# Planning and Zoning Commission

## Monterey Square 25-093PDP

## 25-093PDP - Monterey Square

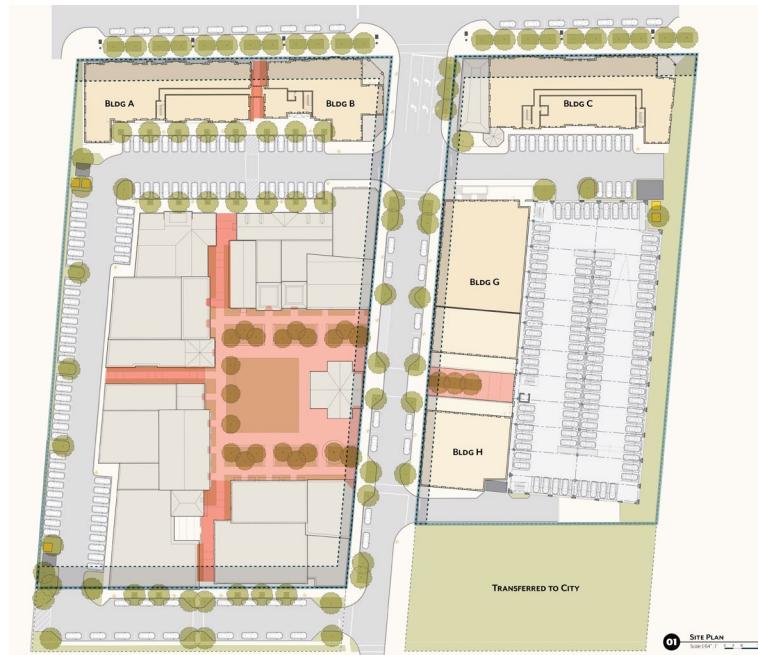
The applicant is proposing one 9'x46' loading zone along the west side of Monterey Drive. This will need to be further analyzed by City staff, along with the Washington Township Fire Department prior to FDP.
